RECEIPT DATE: 2-1-18 **ONSITE SEWAGE DISPOSAL SYSTEM** P 562419

SUBDIVISION: Five Hills Farm LOT: 3 TAX ID: \_\_\_\_\_

RE: Five Hills Farm, Lot 3  
13900 Old Frederick Rd.  
Sykesville, MD 21784  
*(Septic Plan Comments)*

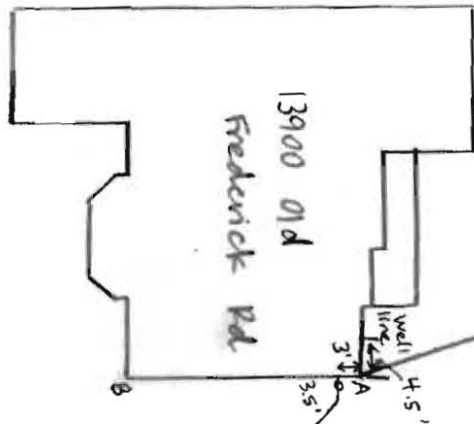
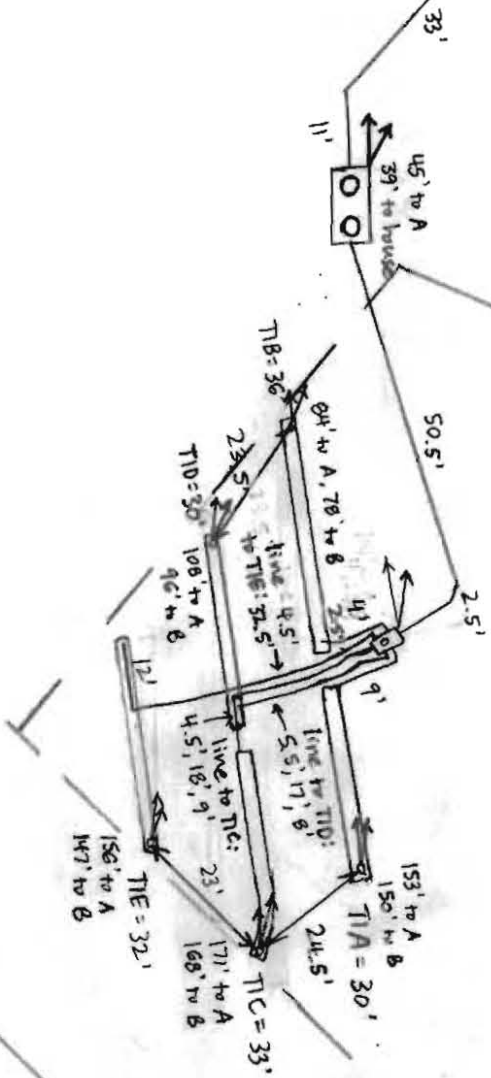
7/12/18 D-box installed + connected to tank and trenches. Levelled speed levelers in D-box. Line from D-box to tank avoids trenches of 2<sup>nd</sup> replacement system. (SC)

3/1/18 Met S. Carroll on site for layout. SDA corner stakes and forest conservation stakes present. Shot contour + laid out 3x57' trenches, length increased slightly b/c sidewall started @ 5' at closest perc hole. Keep tank inside SDA to be outside of 100' Arc from well box. (SC) 4/11/18 Met S. Carroll on site for layout. 3x57' trenches staked out from 3/1 layout. OK to make T1 a few ft shorter + add length to T2 or T3 to get pipes along SDA edge. (SC)

INSTALLATION: 3/5/18 Call from S. Carroll - pipe @ house comes out under footer. Site visit to check elevations: 93.5" to bottom of pipe @ house, 45.5" grade @ tank inlet, 56" grade @ T1. Tank would have 46" cover w/ 1% fall in line from house. Stop work and return plans to engineer for revisions. (SC) 4/23/18 Sewer line run from house to tank location w/ 1% fall. House connection made. (SC) 4/24/18 Tank set + connected to sewer line. (SC) 5/7/18 Call from contractor - cannot make fall to 5' inlet @ T1. Will need revised septic plan. (SC) 7/3/18 Met S. Carroll on site for layout. All 3 systems, tank, + future pump tank staked. Shot contour + starts/ends of initial system trenches are close in elevation. OK for 1A + 1D to be 2' shorter, 1B + 1C to be 2' longer to

stay off trees. (SC)

**SEPTIC PLAN**  
**FIVE HILLS FARM, LOT 3**  
ZONED RC-DEO  
TAX MAP No. 9 GRID No. 7 PARCEL No. 117  
FOURTH ELECTION DISTRICT HOWARD COUNTY, MARYLAND  
SCALE: AS SHOWN DATE: AUGUST, 2017  
SHEET 1 OF 1

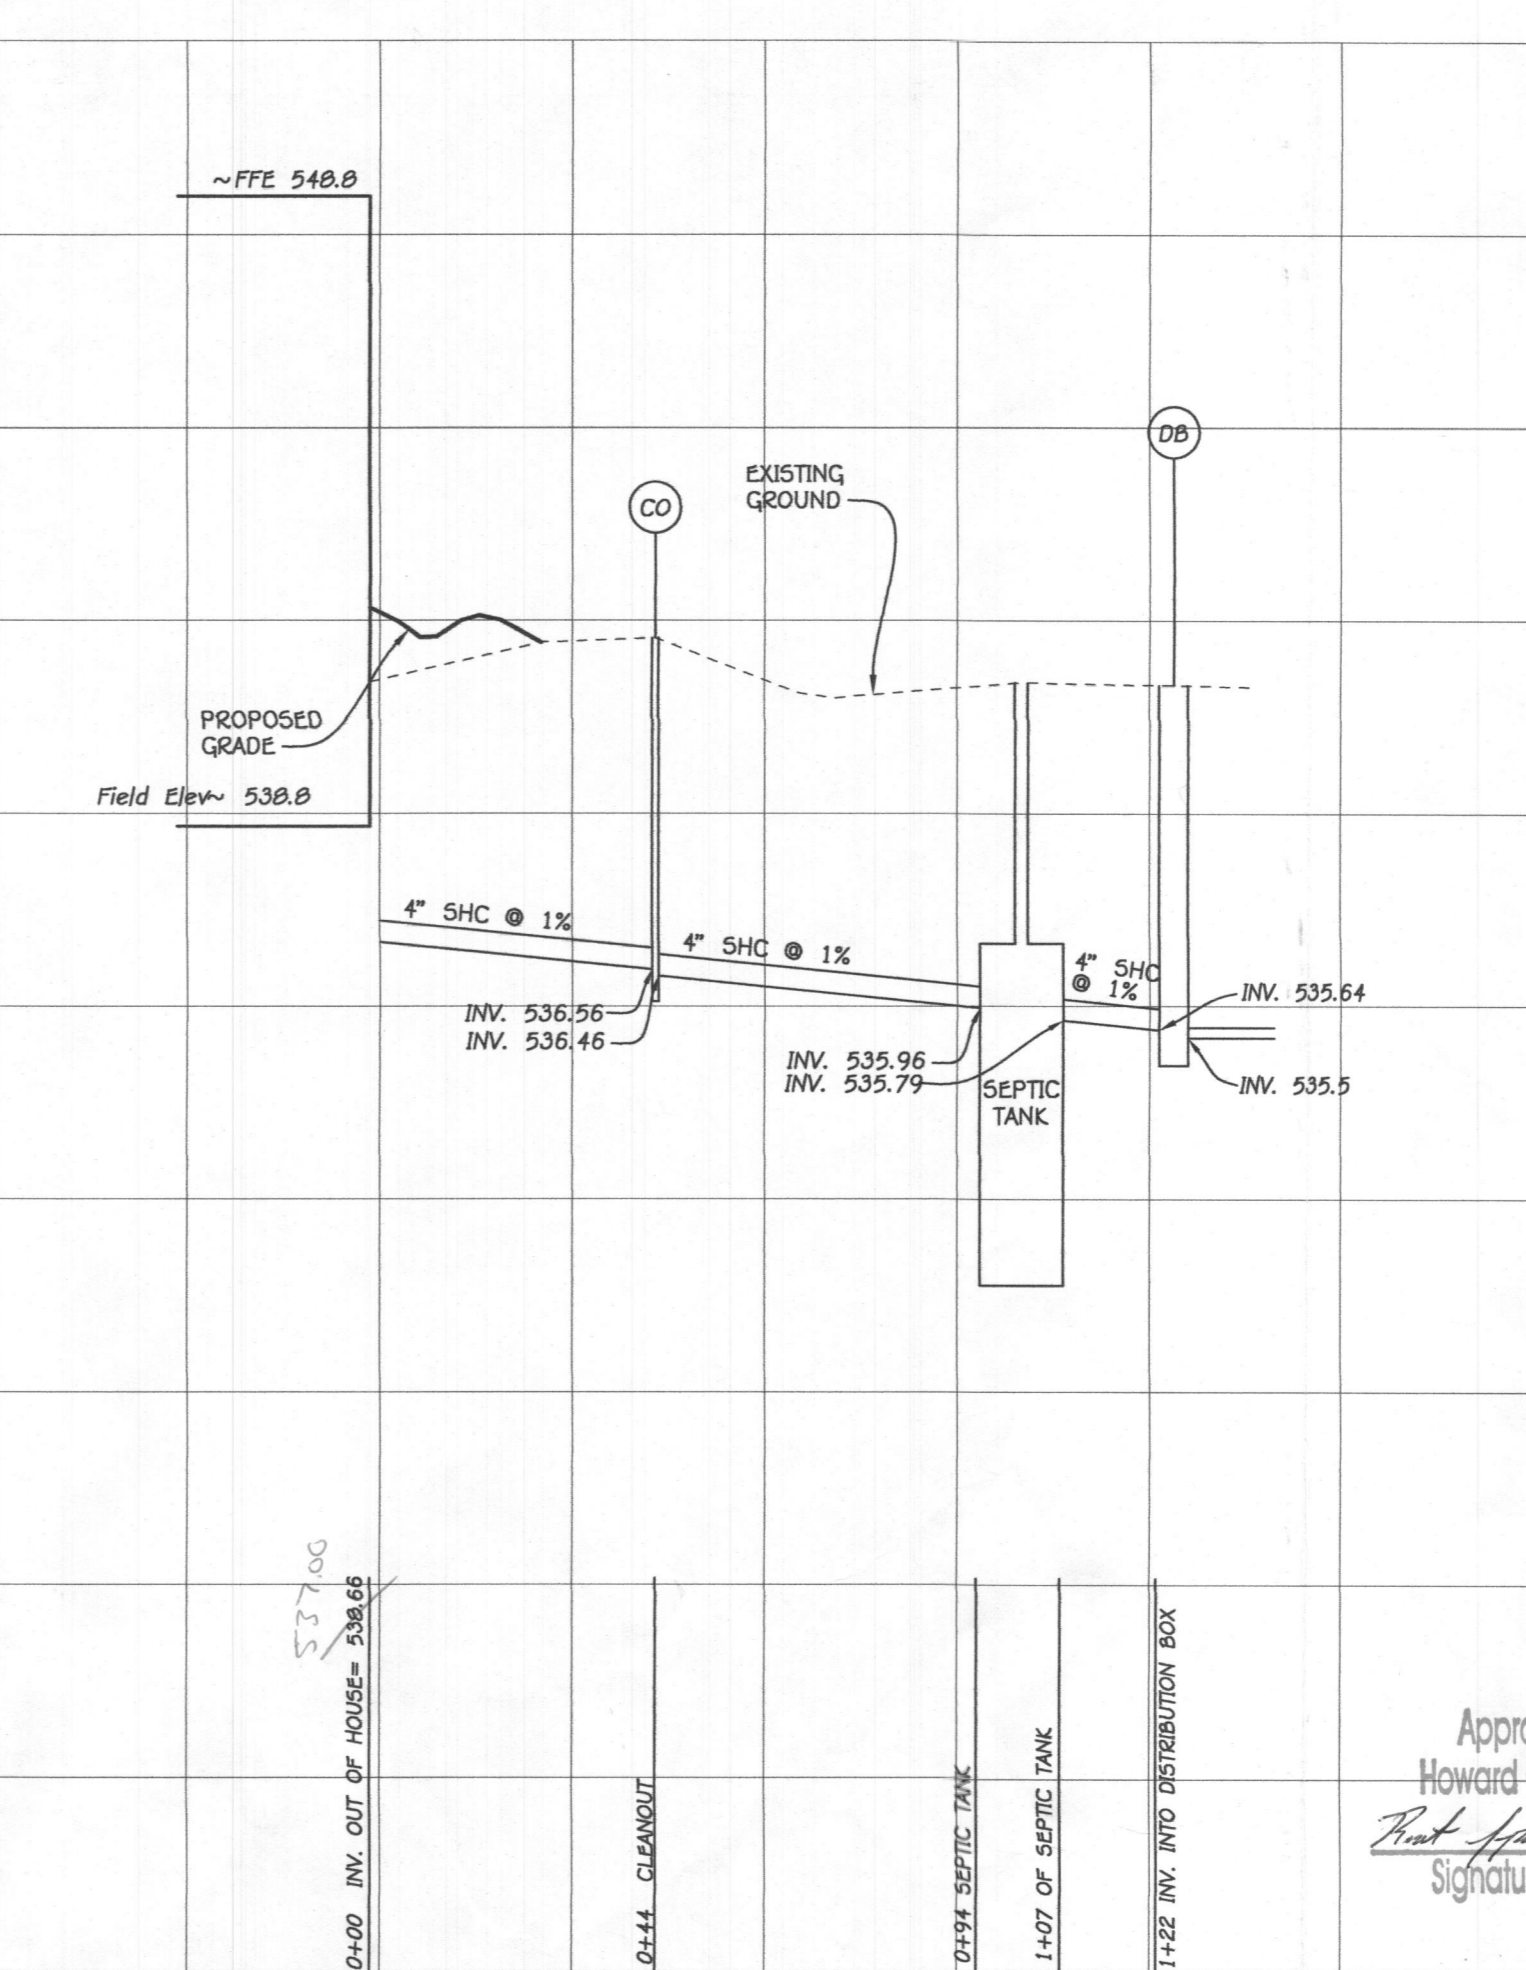
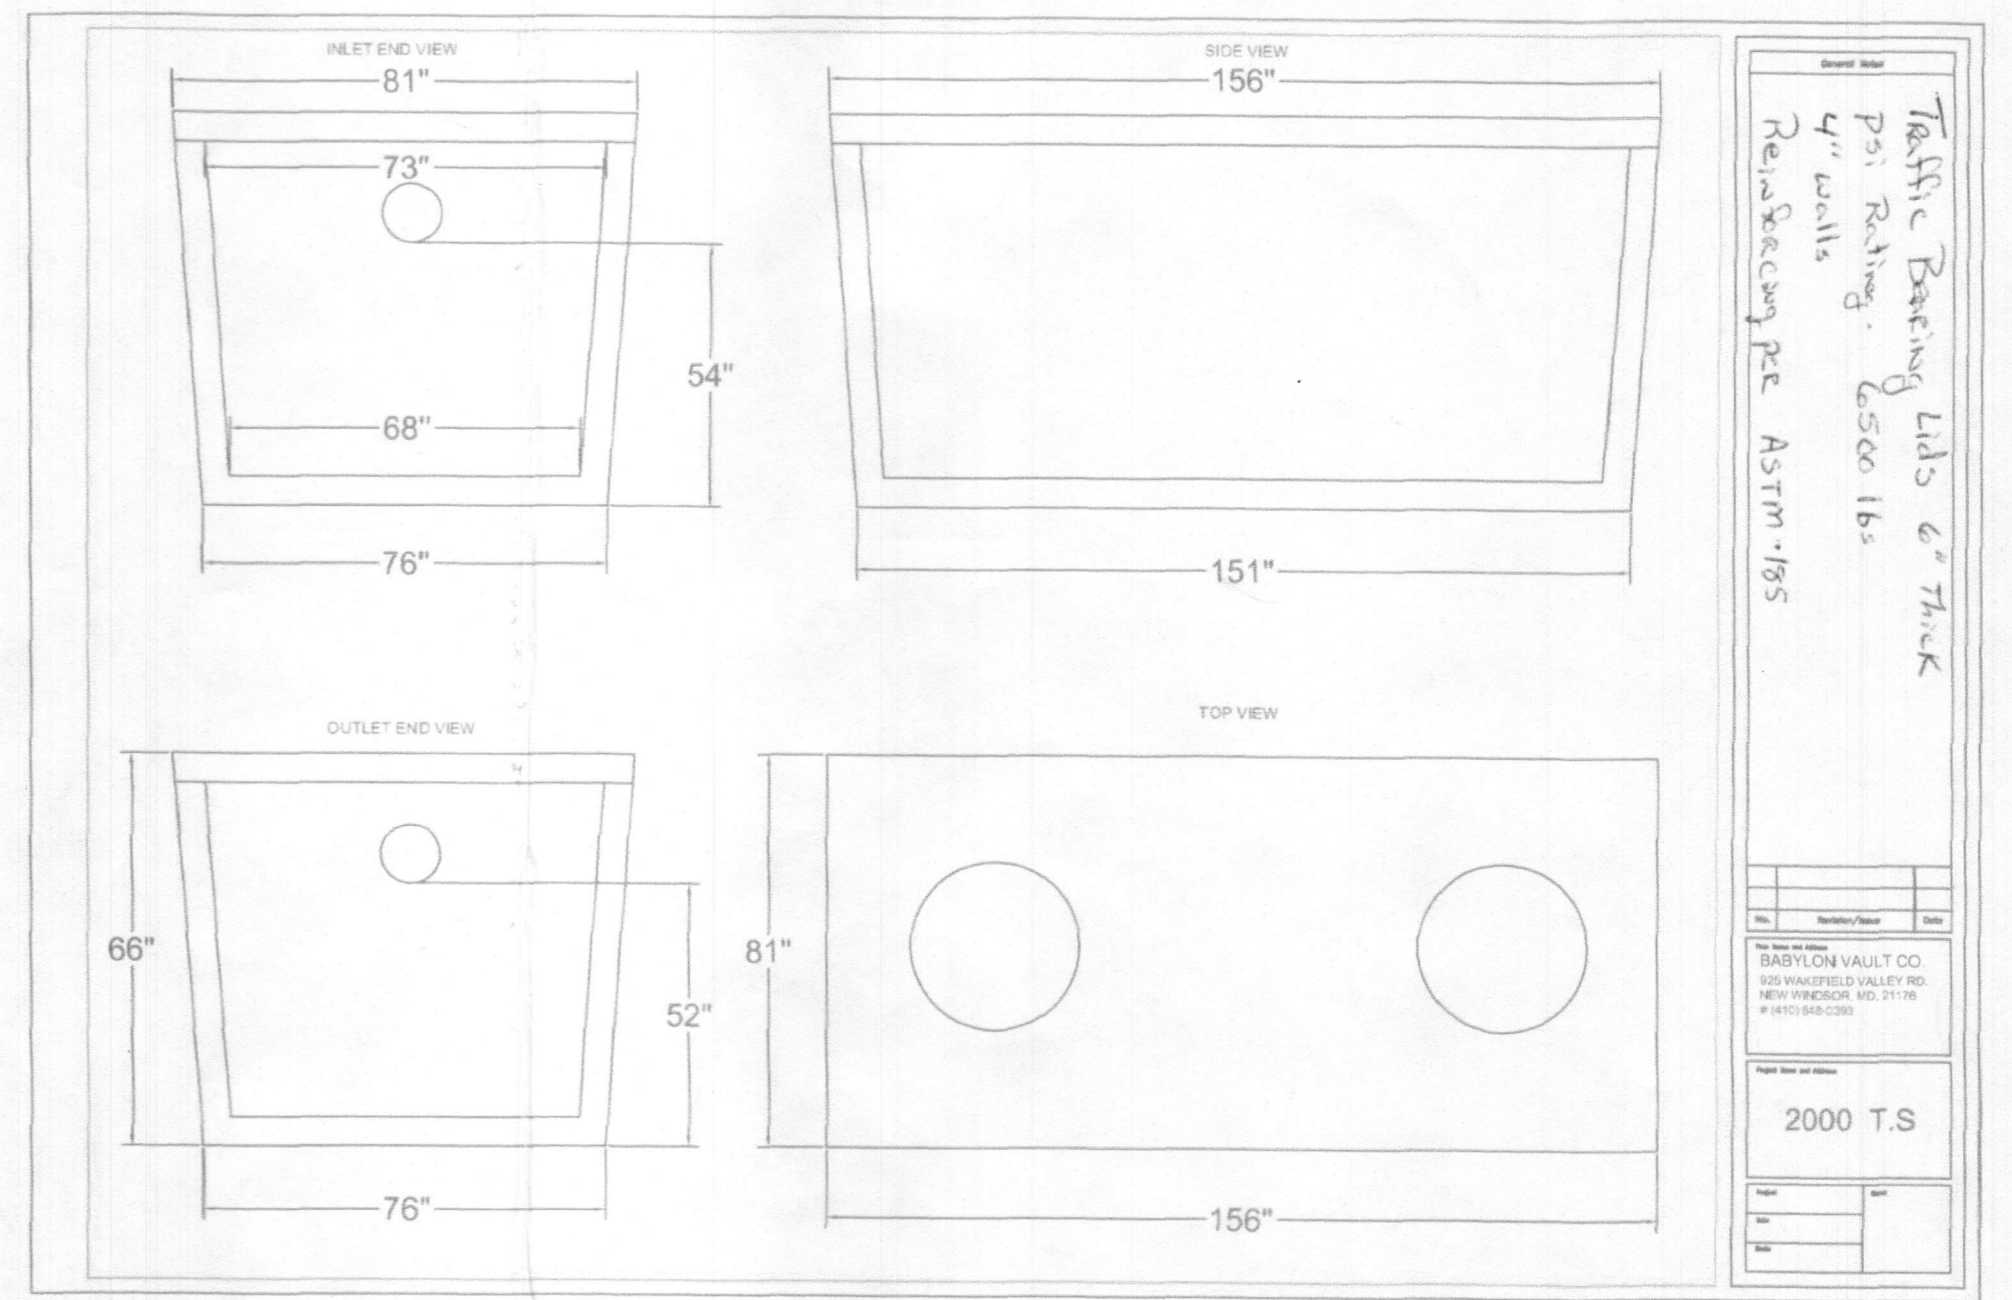
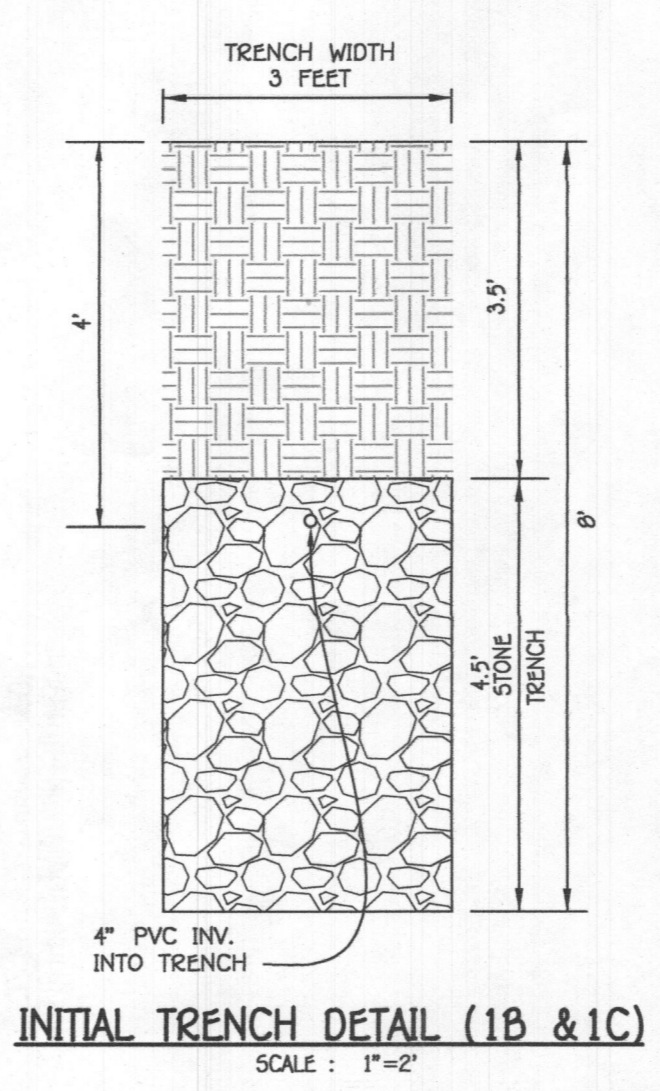
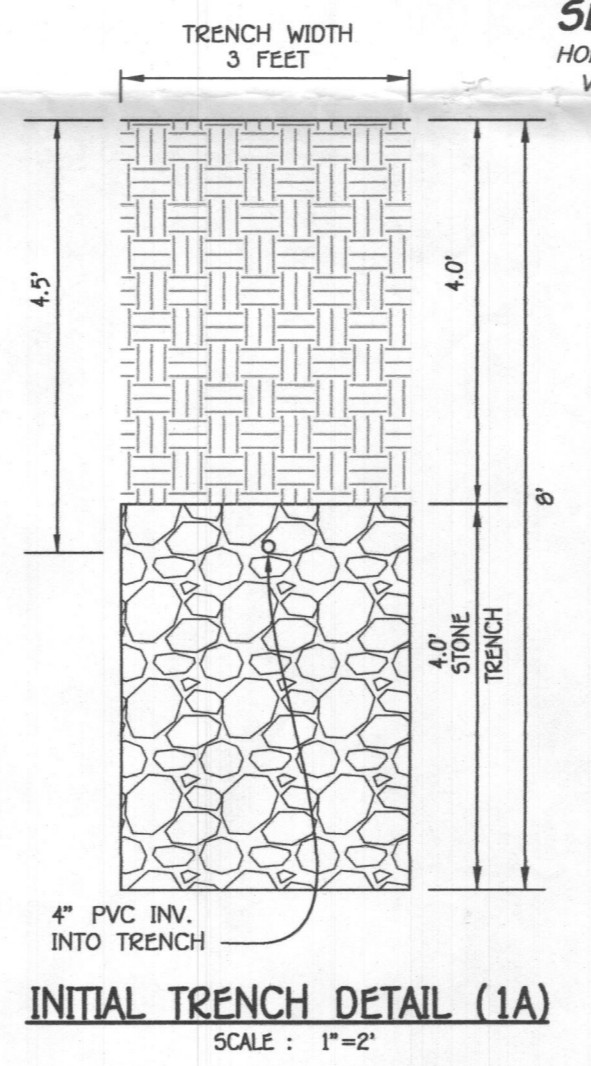
*- If pump system no matter what needs to pump to top trenches.*  
*- Show where pump tank sits, 25' Setback*  
*- Note about pump tank*  
*- Note about stake out*
